AHU-01 Configuration - 60% FD

TITLE: AHU CONFIGURATION OPTIONS  
DATE: 12/12/18  
DRAWN BY: DC

AHU-01 Configuration - Split Unit

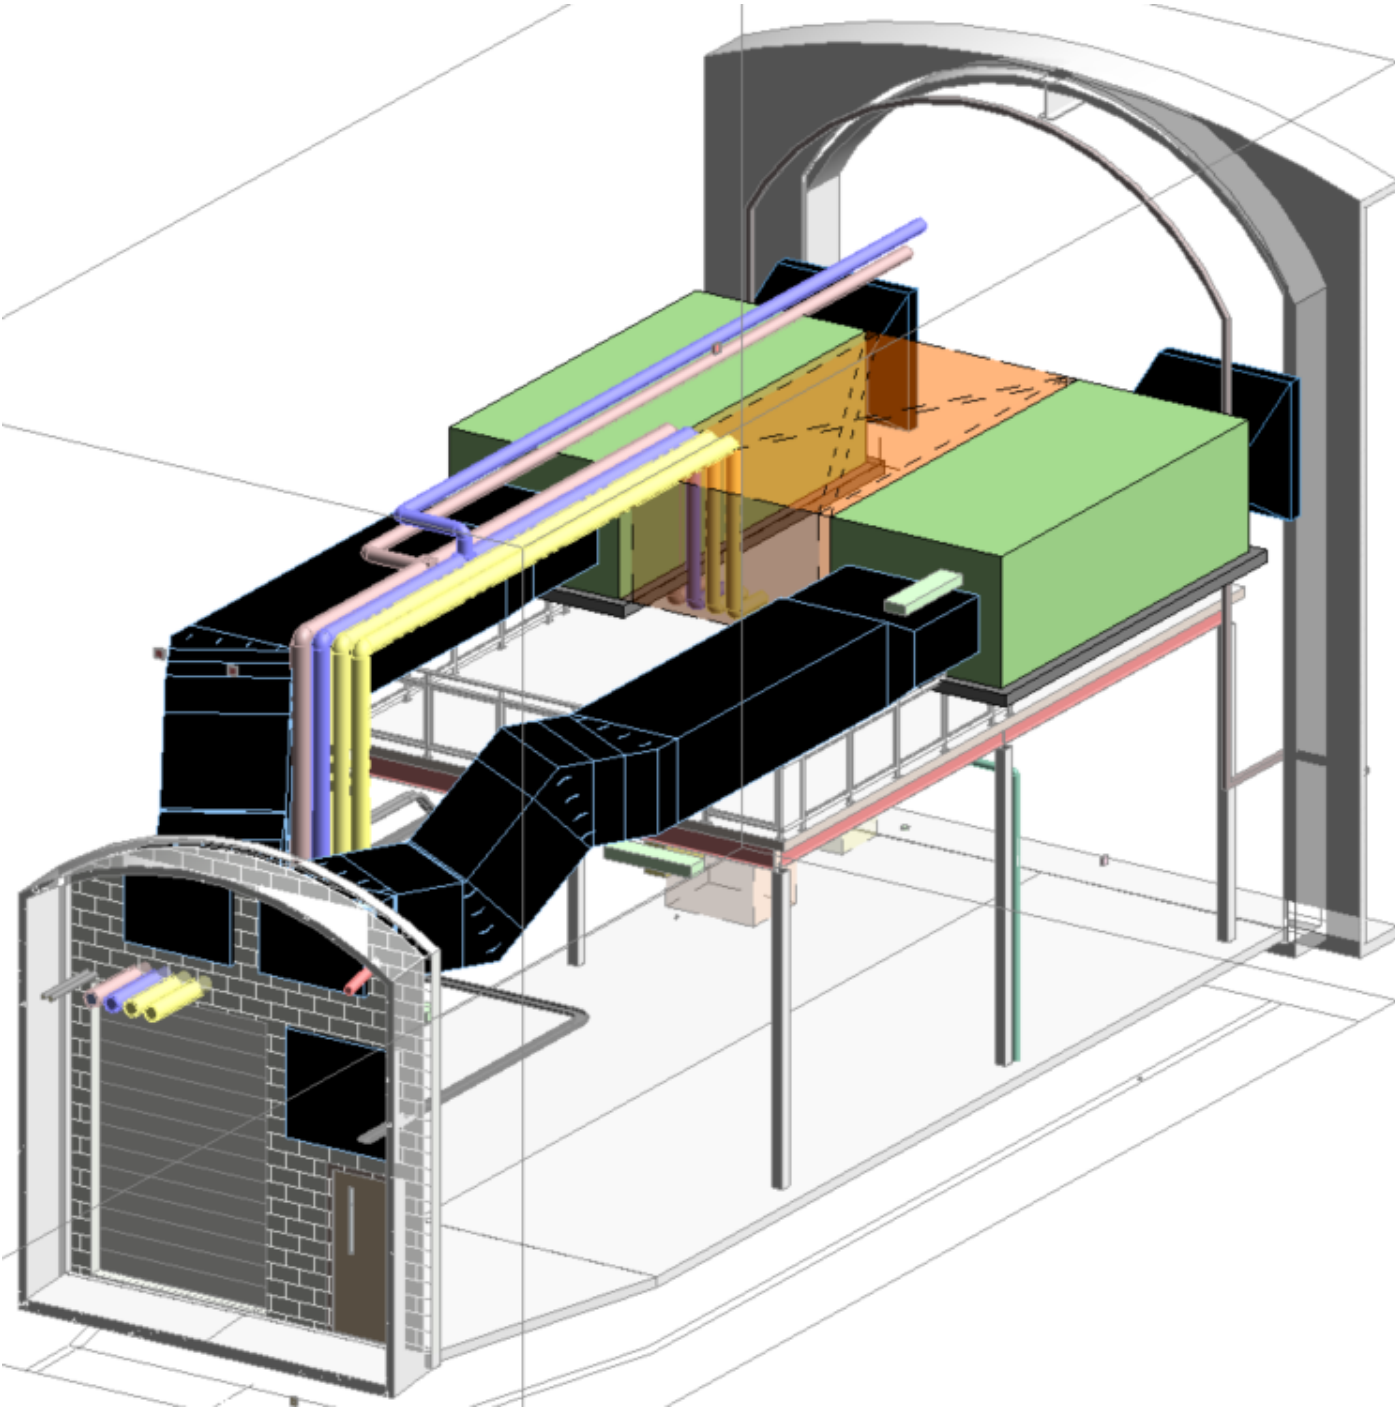
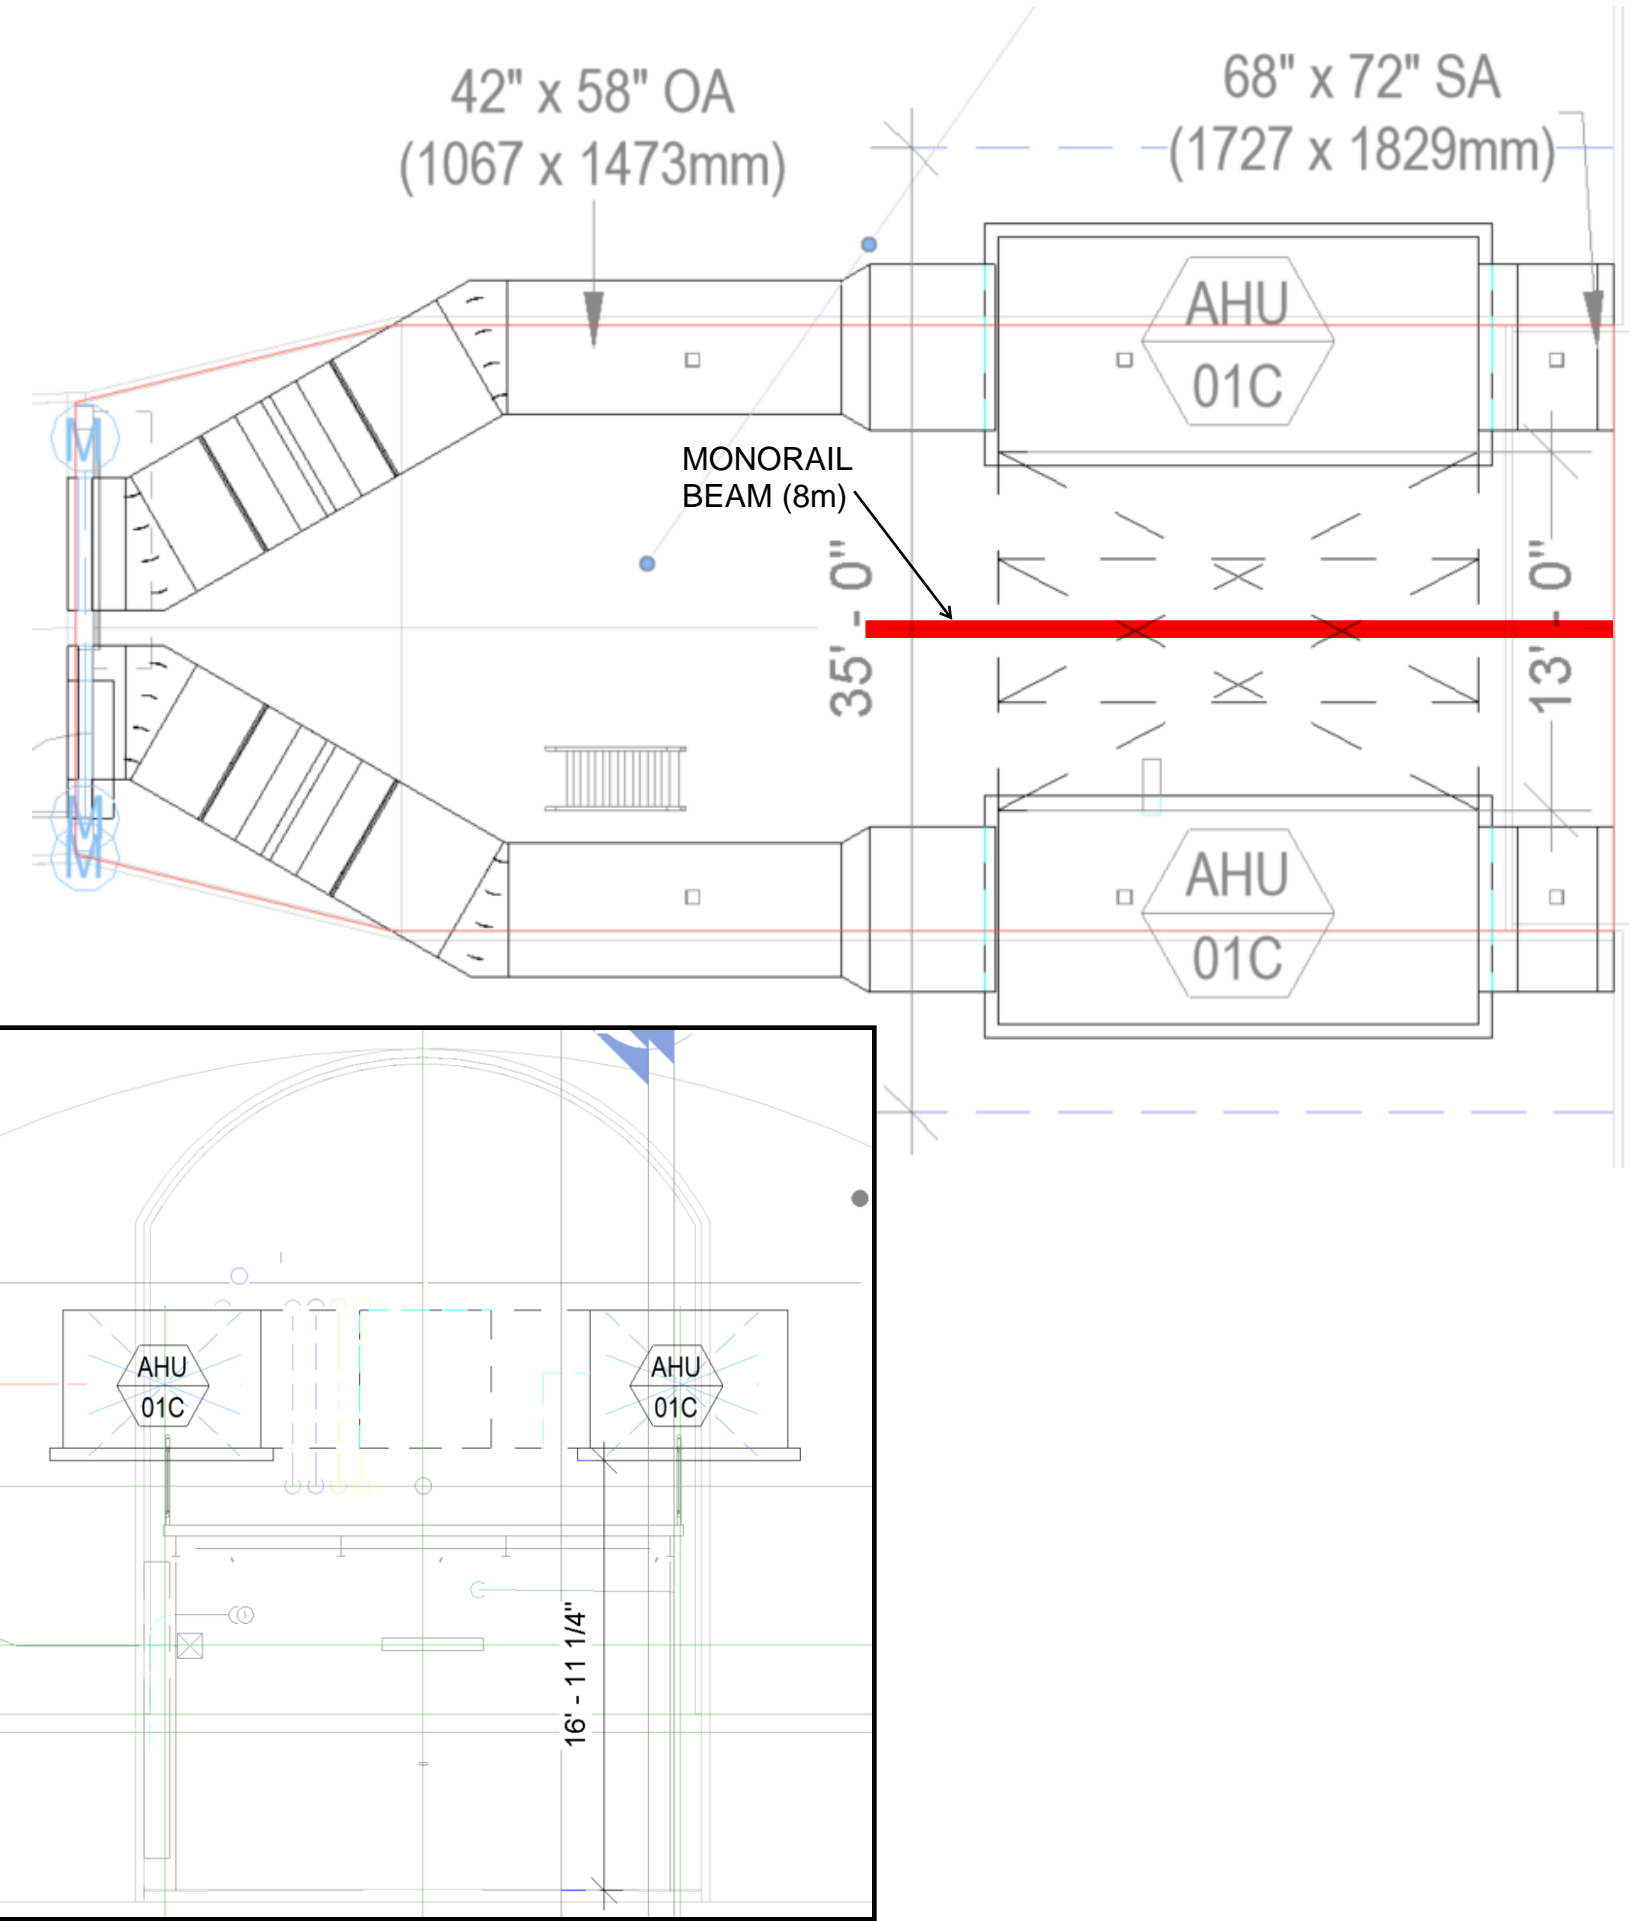
OPTION NOT PREFERRED DUE TO SUPPLY DUCTS  
EXISTING ON BOTH SIDES OF MONORAIL

CHALLENGE FOR FUTURE DUCT CONNECTION  
CROSSING MONORAIL BEAM

AHU-01 Configuration - Floor Level Horizontal

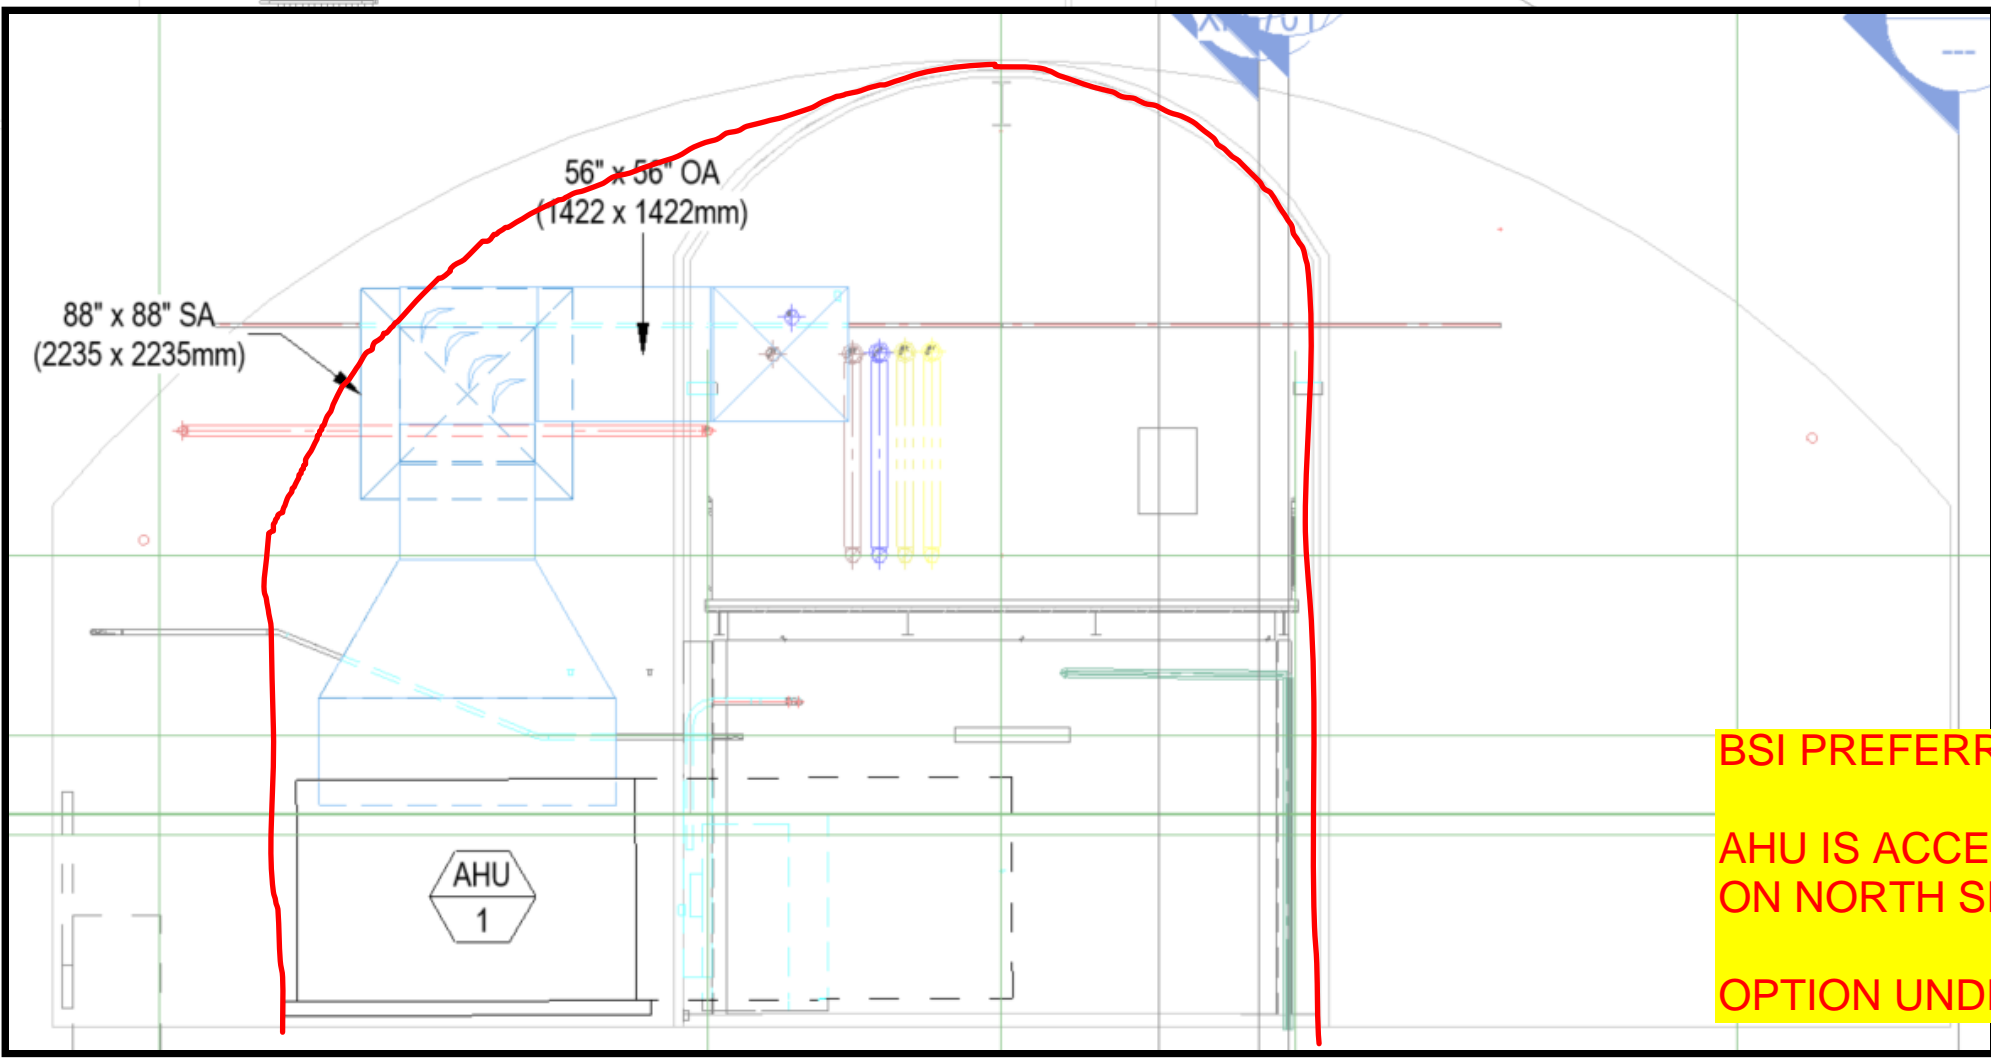
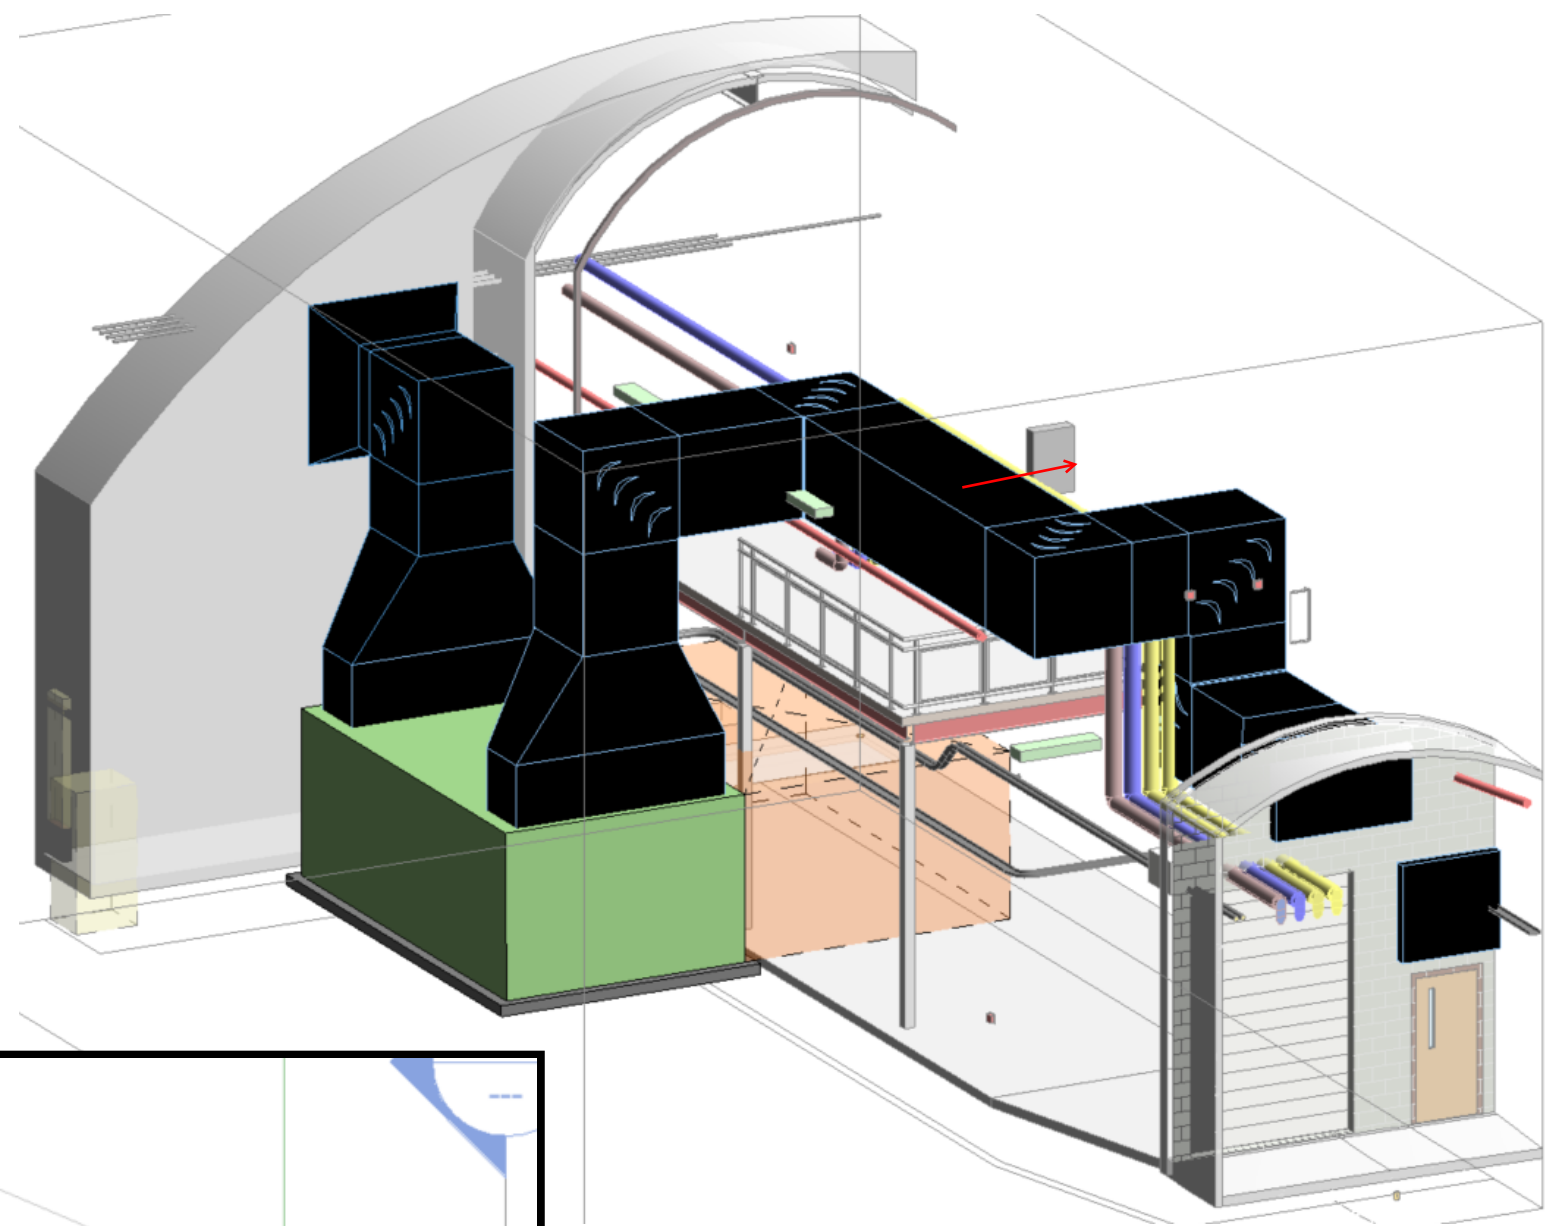
BSI PREFERRED OPTION

AHU IS ACCESSED FROM LOW LEVEL AND SUPPLY DUCT IS ON NORTH SIDE OF CAVERN (FOR FUTURE CONNECTION)

AHU-01 Configuration - Floor Level Vertical

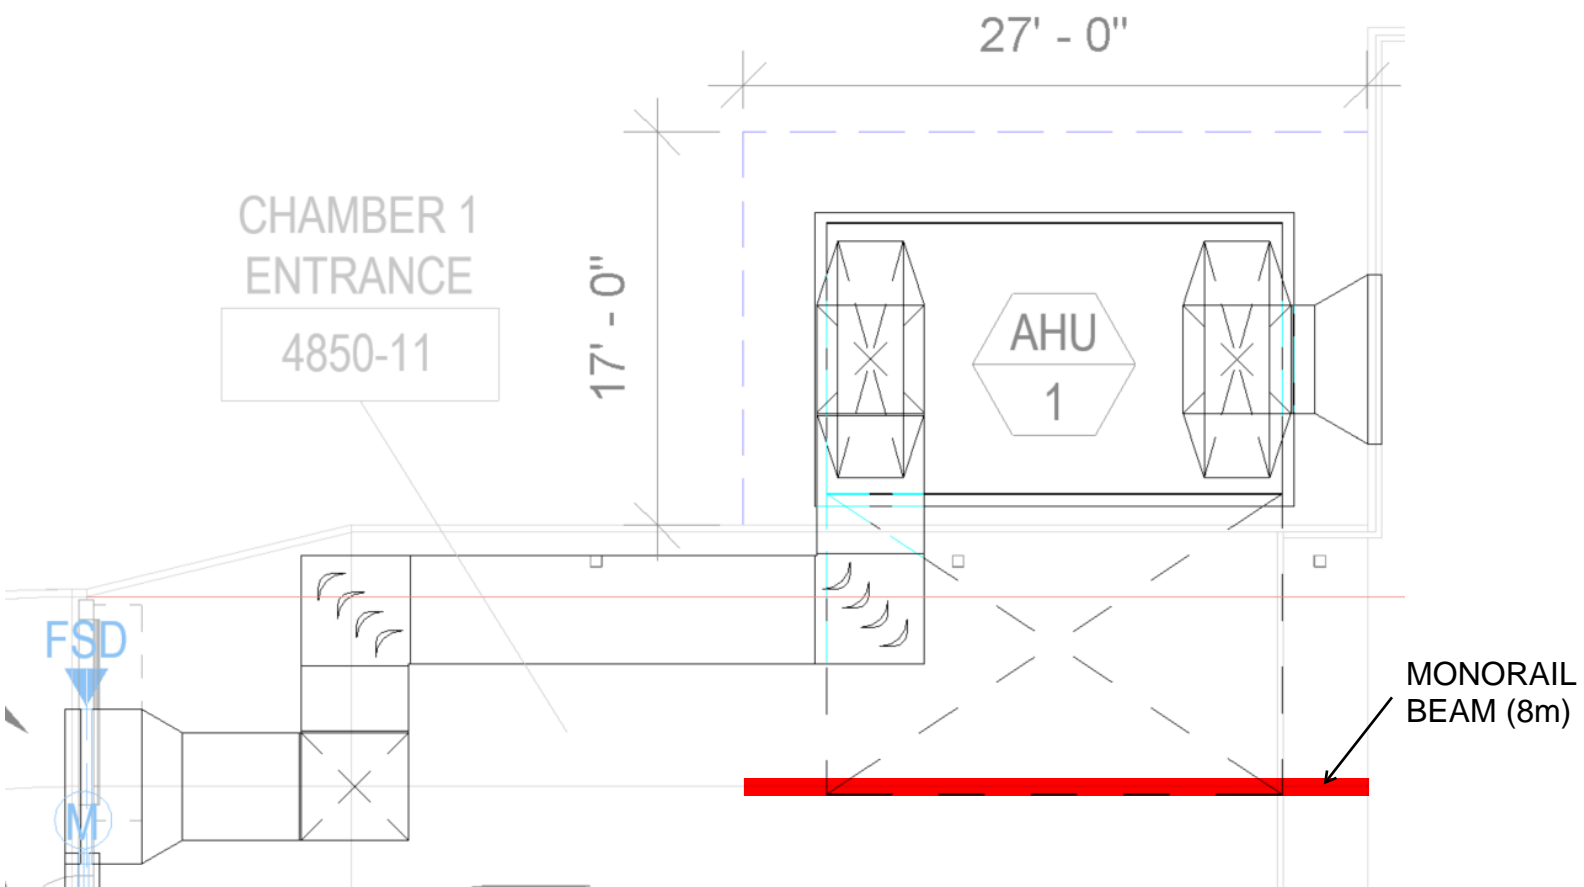
OPTION UNDER REVIEW FROM GEOTECH
